**RESPONSE TO COMMENTS**  
**WY 2020 Annual Report**  
**Indian Wells Valley Groundwater Sustainability Plan**  
**February 2, 2022**

The following comments were compiled from phone calls, emails, and Technical Advisory Committee (TAC) review of the WY 2020 Annual Report. Based on these comments, the following recommendations are presented for improving the Annual Reports and the 2025 5-Year Report for the Groundwater Sustainability Plan (GSP):

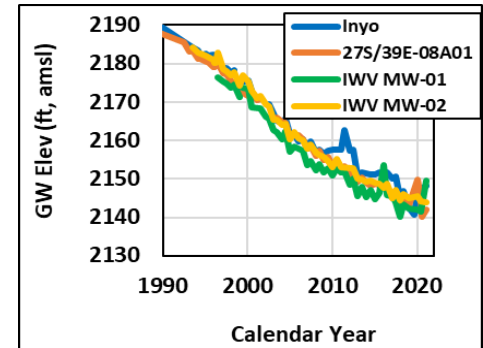
32	Tim Parker, specific comment	11) Figure 5-3 - Why not use/stick to SGMA terminology for “Representative Monitoring sites or points?”	The terminology has been updated in the WY 2021 Annual Report to use “Representative Monitoring Sites”.
